SAFETY EVALUATION REPORT

REQUEST FOR ALTERNATE DISPOSAL APPROVAL AND EXEMPTIONS FOR SPECIFIC HEMATITE DECOMMISSIONING PROJECT WASTE AT US ECOLOGY'S IDAHO FACILITY

January 15, 2014

Figure 3-1: Intruder Scenario Waste Concentration Assumptions

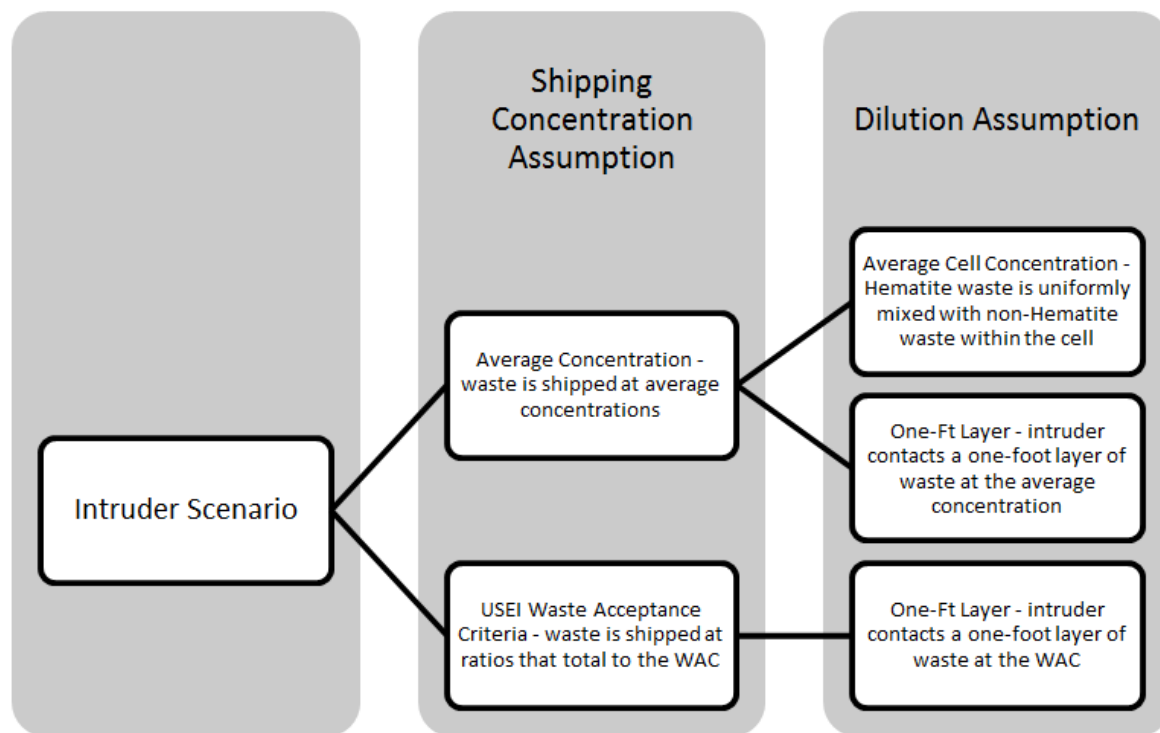
The analysis from the May 2009 request is summarized in the following paragraphs for convenience. The analyses included variations on assumptions about the concentration of the material as it is shipped and the extent to which the shipping concentrations are diluted once it has been disposed of in the cell as detailed in Figure 3-1. WEC did not evaluate the Average Cell Concentration Scenario for material shipped at the Waste Acceptance Criteria (WAC) for all radionuclides because the volume of material and concentration limits for Tc-99 prevent WEC

from shipping the total volume of waste under this request at the WAC. Instead, WEC analyzed the dose assuming that the total volume was shipped at the WAC containing uranium, but not containing Tc-99.

The NRC staff considered the assumptions and pathways for the intruder scenarios to be reasonable based on comparison to the guidance in Appendix G of NUREG-0782 and NUREG/CR-4370, Volume 1.

Staff considers the dilution factor of 0.31 acceptable for the Construction One-Ft Layer scenario after reviewing the standard practices at USEI. Staff also considered the dilution factor of 0.53 acceptable for the Average Cell Concentration scenario after reviewing historical data for waste volumes sent to USEI. The staff notes the following conservatisms were presented in Section 7.2 of Enclosure 1 WEC's January 2012 submittal:

Figure 5-1: Reactivity of uranium in matrix material versus concentration

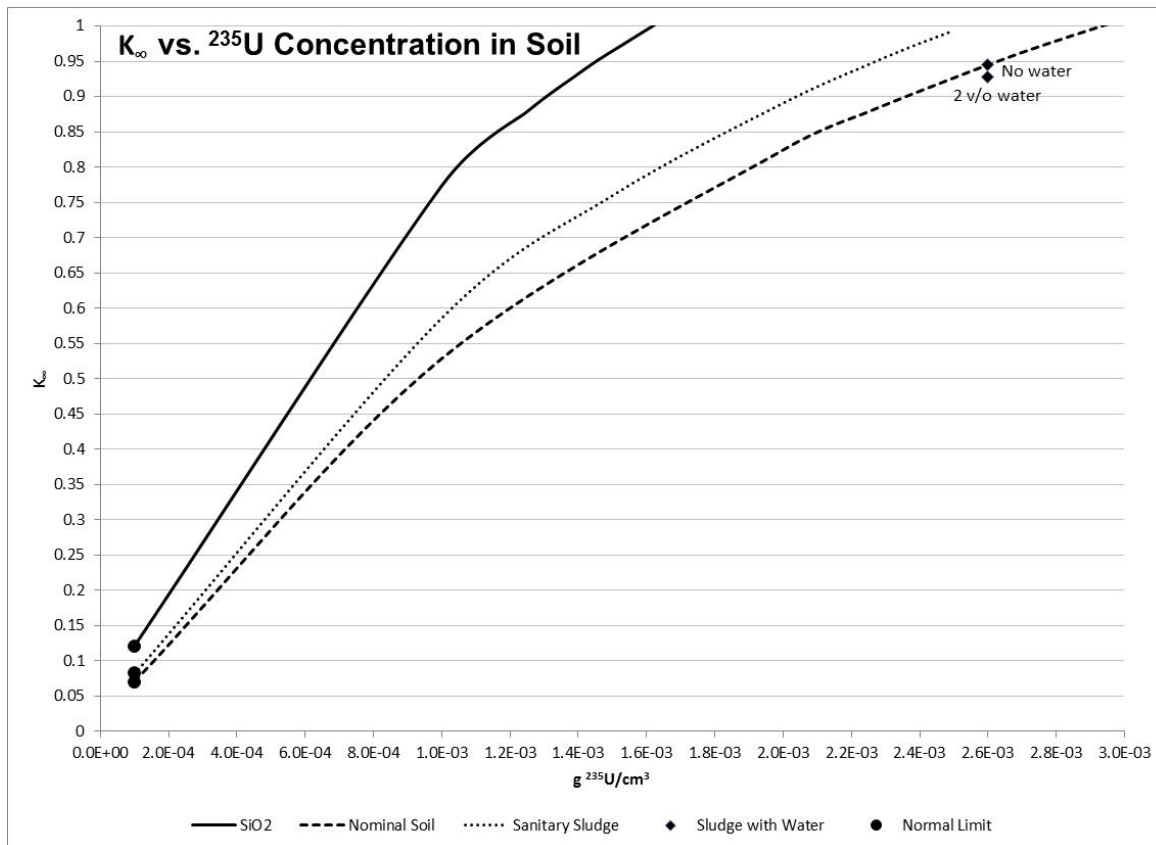
The staff performed a series of sensitivity calculations using the SCALE 6.0 computer package, to first confirm the results of calculations in NUREG/CR-6505, Vol. I, for SiO_2 and nominal soil, and then to compare these results to waste with sanitary sludge as the matrix material. The staff varied the concentration of U-235 to verify the adequacy of the 0.1 g U-235/l limit for each of the matrix materials, and to determine the amount of safety margin in this limit. The safety margin was represented by the maximum safe concentration factor, which was taken to be the concentration at which k_{eff} exceeds 0.95 divided by the concentration limit of 0.1 g U-235/l. The staff also varied the concentration of water, although in general adding water to the waste material resulted in a net decrease in k_{eff} . The waste material was modeled as infinite in all three dimensions by applying mirror boundary conditions on a cuboid filled with a homogeneous mixture of waste consisting of the matrix material, fully-enriched uranium, and water. Because soil and sludge are highly porous materials, uranium and water were assumed to fill up the voids in the matrix material, so that the density of the matrix medium remained unchanged as uranium and water were added to it. (This maximizes the overall bulk density, though in an infinite system k_{eff} is insensitive to the bulk density.) For the sludge, certain isotopes were not represented in the SCALE Standard Composition Library (e.g., zinc and mercury, and only the As-75 and Ba-138 isotopes could be used). These trace materials were neglected, and the relative abundance of oxygen increased so the weight percent of all species totaled to 100%. The graph below shows the change in k_{eff} thus determined as a function of uranium loading, with no water present:

The staff's calculations showed that, over the whole range of uranium concentrations, SiO₂ is still the bounding matrix medium, and sanitary sludge (as modeled) is slightly more reactive than nominal soil. While the sludge contains more neutron poisons, its density is lower than soil (0.72 g/cm³ instead of 1.6 g/cm³). Thus, at the same uranium concentration, uranium will have a higher relative concentration (in terms of g U-235/g waste) in sludge than in soil. Also shown are results for the sludge calculation closest to $k_{\infty} = 0.95$ with no water present and with 2 v/o (volume percent) water. This shows that the addition of water results in a slight decrease in reactivity, so dry waste is the most bounding. The circles represent the case in which uranium concentration is at its normal limit of 0.1 g U-235/l, or 10-4 g U-235/cm³. The results show that for SiO₂ soil, it would require the concentration to increase to 14.5 times its normal limit before criticality is possible. For nominal soil, the factor is 26.3 times the normal limit, while for the sanitary sludge, the factor is 22.7 times the normal limit.

These concentration factors are the lowest such factors for which criticality is possible, based as they are on homogeneous mixtures infinite in all directions. In NSA-TR-HDP-11-11, using the results of NUREG/CR-6505, WEC demonstrated that an even higher concentration is needed given the finite extent of the landfill cells. Tables C-1 and C-2 of NUREG/CR-6505, Vol. 1, give k_{∞} values and (when an infinite medium is critical) safely subcritical slab thicknesses, cylinder diameters, and sphere diameters, for various concentrations of uranium and water in SiO₂ and nominal soil. At a concentration of 0.006 g U-235/cm³ (used as a typical value in NUREG/CR-6505), a slab that is infinite in two dimensions attains a k_{eff} that exceeds 0.95 at an areal density
